Rezoning Transportation Analysis
Petition Number: Insert Zoning Petition #2021-241
General Location Identifier: 10537220

Date	Description
03-21-2022	First Review (AO)
04-19-2022	Second Review (AO)

Outstanding Issues

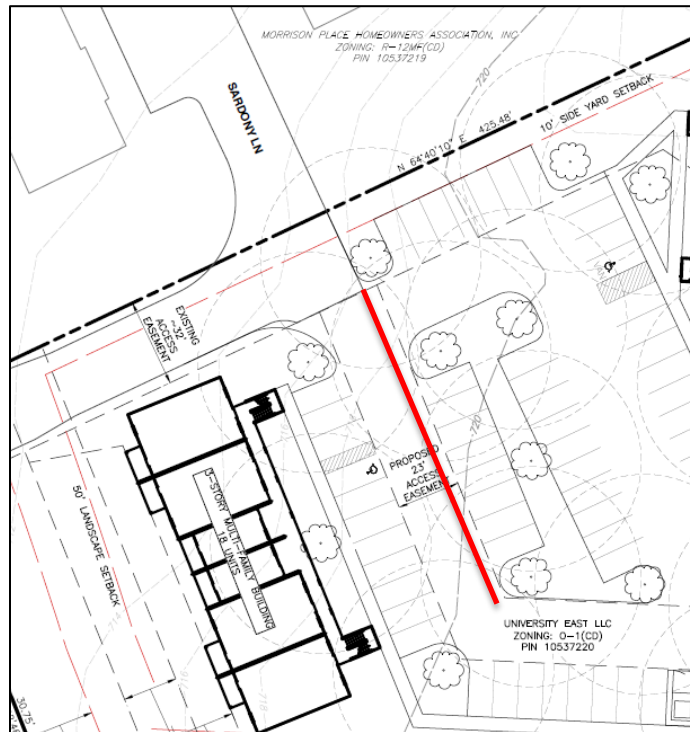
~~2. Revise site plan and conditional note(s) to commit to dedicate 100 feet of right of way from the road centerline of WT Harris Blvd. The site plan shall label and dimension the right of way from the road centerline.~~

~~3. Revise site plan to align proposed driveway aisle with existing Sardony Ln.~~
